# PIC16C65

## PIC16C65 Rev. A Silicon Errata Sheet

## Clarifications/Corrections to the Data Sheet:

**FIGURE 1: WRITES TO TIMER1 (EXTERNAL CLOCK / OSCILLATOR MODE)**

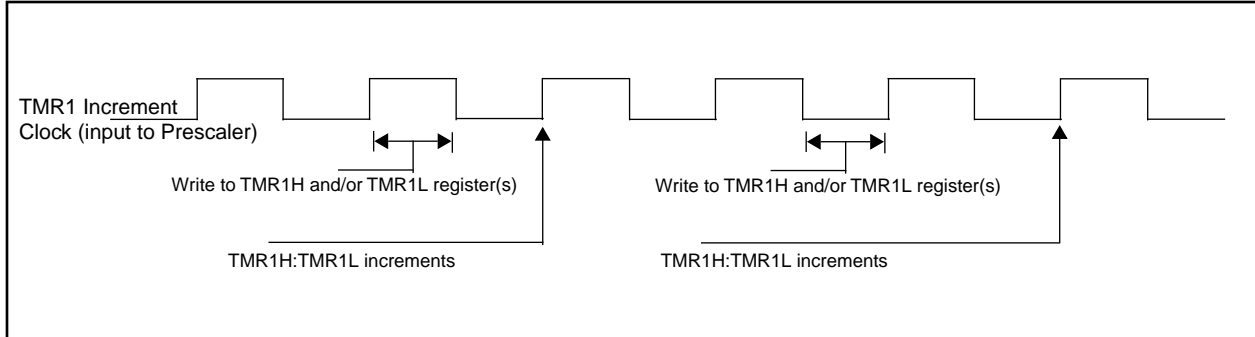
- a) The operation of Timer1 needs some clarification when the timer registers are written when the TMR1ON bit is set.

The internal clock signal that is the input to the TMR1 prescaler affects the incrementing of Timer1 (TMR1H:TMR1L registers and the Timer1 prescaler). When the Timer1 registers are NOT written, the Timer1 will increment on the rising edge of the TMR1 increment clock.

When the TMR1H and/or TMR1L registers are written while this clock is high, TMR1 will increment on the next rising edge of this clock.

When the TMR1H and/or TMR1L registers are written while this clock is low, TMR1 will not increment on the next rising edge of this clock, but must first have a falling clock and then the rising clock for TMR1 to increment.

Figure 1 shows the two cases of writes to the TMR1H and/or TMR1L registers. Due to the V<sub>IH</sub> and V<sub>IL</sub> thresholds on the oscillator/clock pins, external

Timer1 oscillator components, and external clock frequency, the Timer1 increment clock may not be of a 50% duty cycle.

The TMR1 increment clock is out of phase of the T1OSO/T1CKI pin by a small propagation delay.
